Sheet: /	
File: Arduino_shield.kicad_sch	
Title: HP5341A A19 replacement board	
Size: A4	Date: 2023-09-22
KiCad E.D.A. 9.0.1	Rev: 0.2
	Id: 1/1

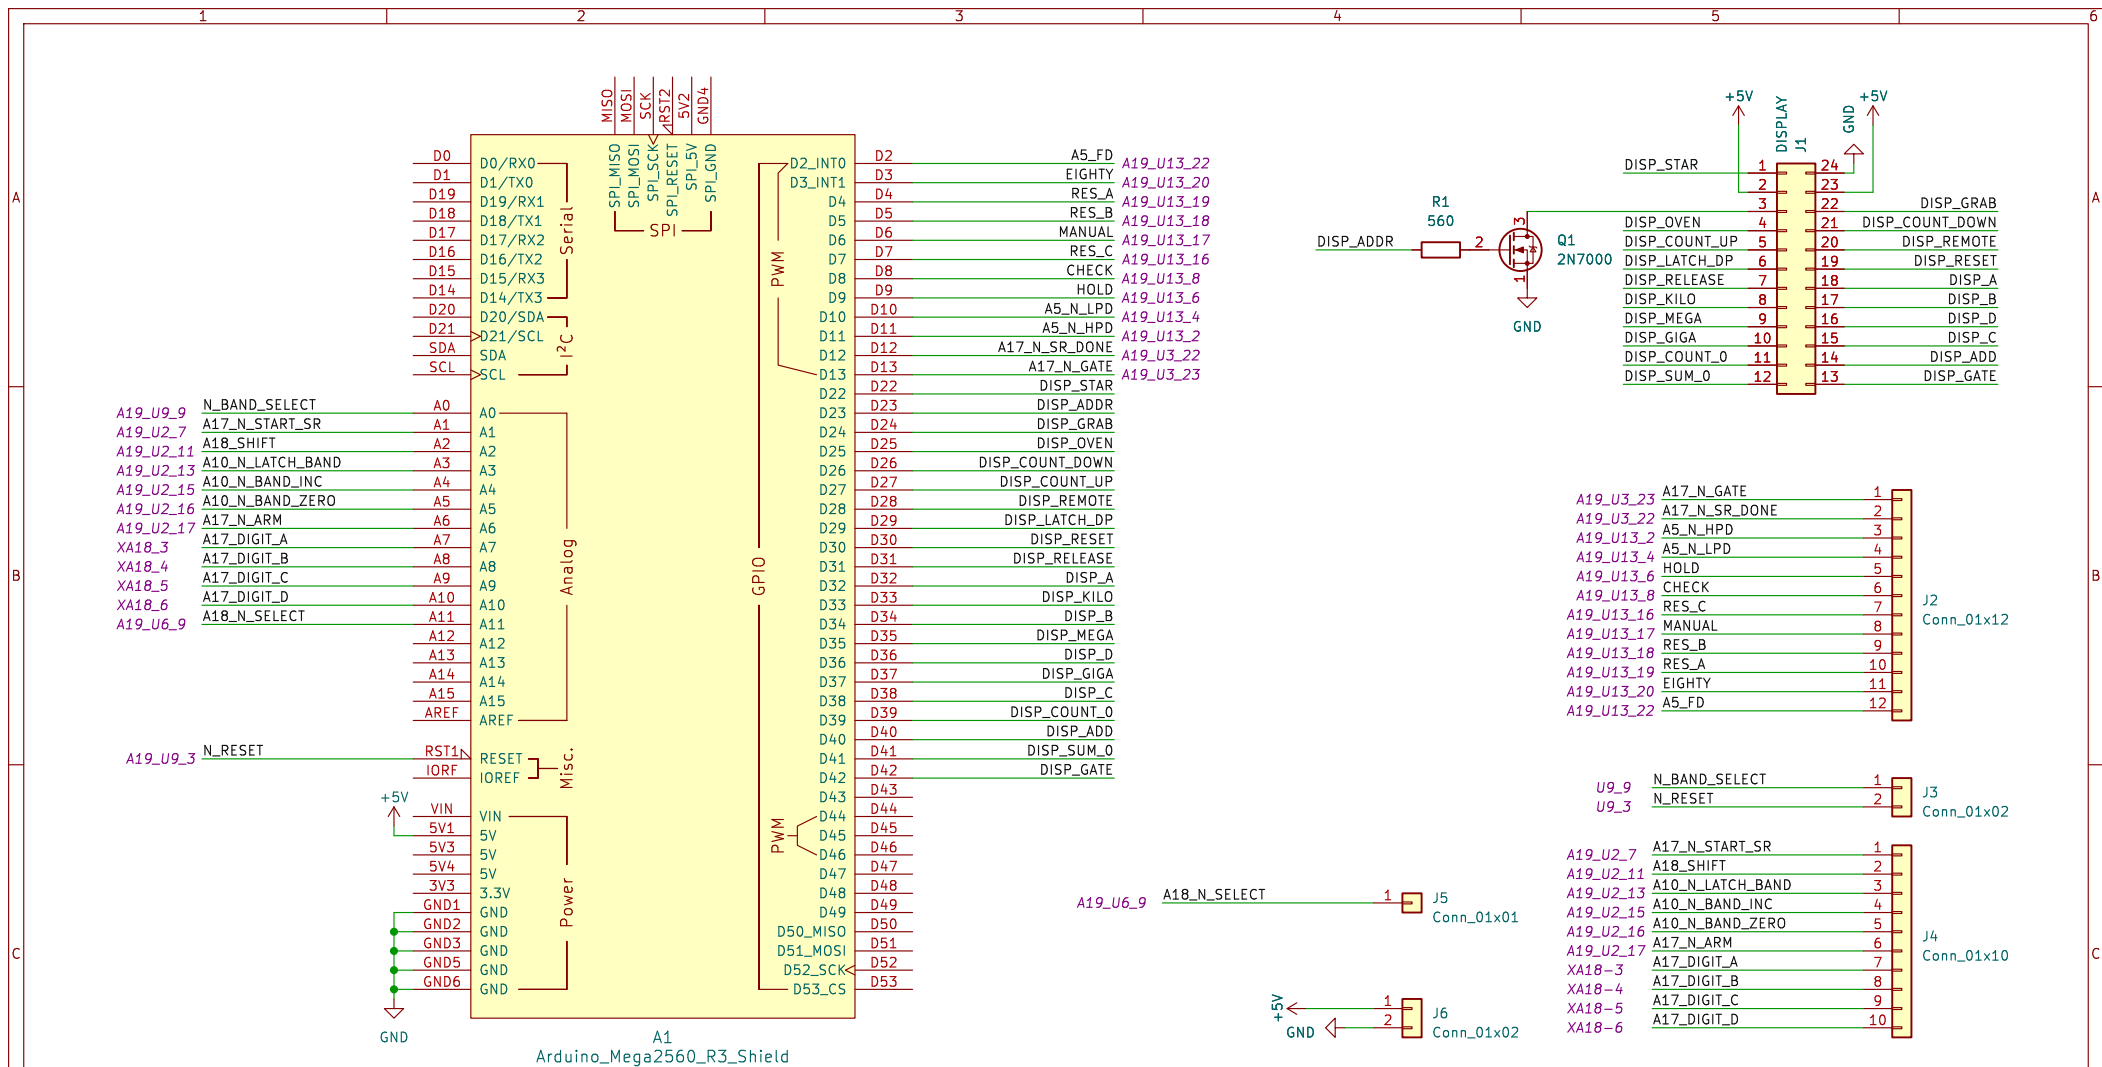
NOTE: DISCONNECT POSITIVE WIRE FROM ARDUINO USB!!!

MODIFICATIONS ON A19 BOARD:

- remove U13
- remove U9
- connect U9_2 to GND
- remove C1
- remove Q1, C2
- remove U2
- remove U6
- remove U15
- remove U3
